State of California
Department of Fish and Wildlife

Memorandum

Subject: COMMENTS ON THE NOTICE OF AVAILABILITY FOR PUBLIC COMMENT OF A DRAFT ENVIRONMENTAL IMPACT REPORT FOR THE WATER QUALITY CERTIFICATION OF PACIFIC GAS AND ELECTRIC COMPANY'S UPPER NORTH FORK FEATHER RIVER HYDROELECTRIC PROJECT FEDERAL ENERGY REGULATORY COMMISSION PROJECT NO. 2105 AND UPPER NORTH FORK FEATHER RIVER HYDROELECTRIC PROJECT DRAFT ENVIRONMENTAL IMPACT REPORT, NOVEMBER 2014, FERC PROJECT #2105

Figure 7-34. Comparison of the performances of the LPHI with levees not removed and Curtain No. 4 for August condition.

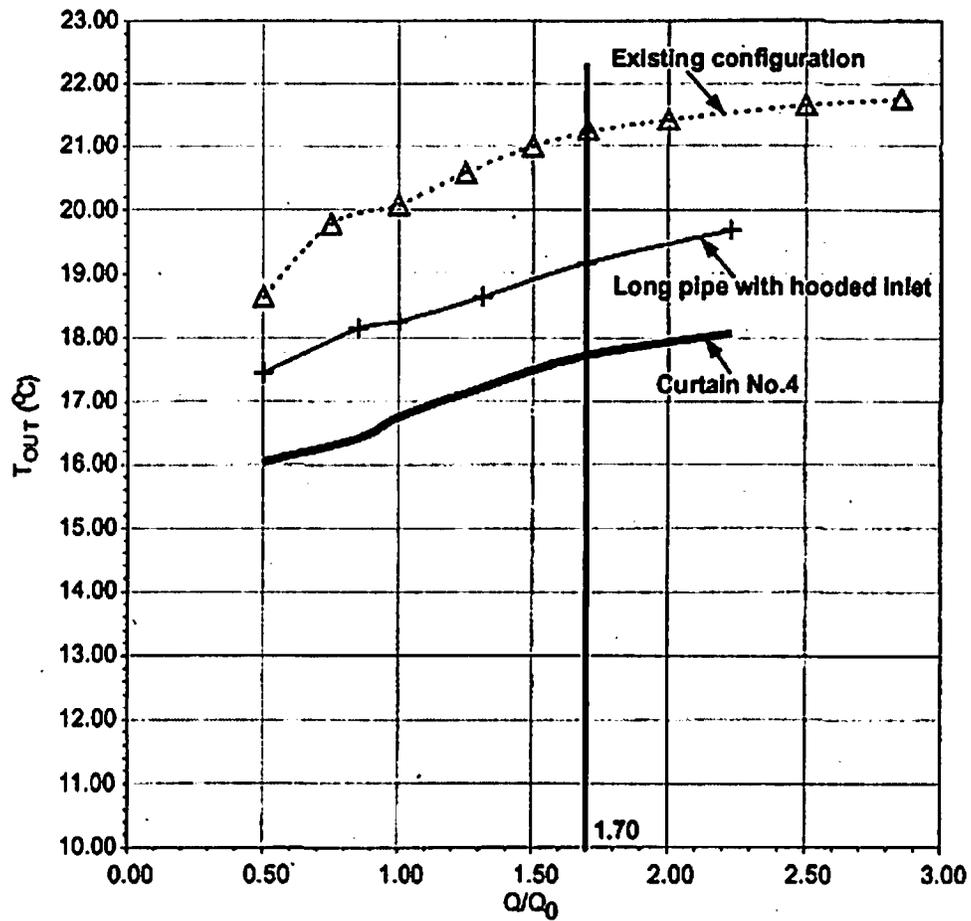
Given the fact that the Board has determined that the installation of a thermal curtain would have significant and unavoidable aesthetic impacts at the Prattville intake, the Department recommends re-evaluating a long hooded pipeline as an alternative for the Prattville intake in combination with thermal curtains in Butt Valley. Although a hooded pipeline may not be as effective at reducing water temperatures in the river as thermal curtains, physical modeling indicated that it could reduce water temperature significantly and the aesthetic impacts would likely be less than significant. The following graphs are Figures 7-34 and 7-35 from the Lake Almanor Cold Water Feasibility Study: Hydraulic Model (Ettema, et al., 2004). These graphs compare the different variations of a curtain and a long hooded pipeline both with and without the currently existing underwater levees:

The long pipe with hooded inlet option may have the benefit of reducing temperatures in the river to more acceptable levels for cold water species, with less depletion of the cold water pool in Lake Almanor.
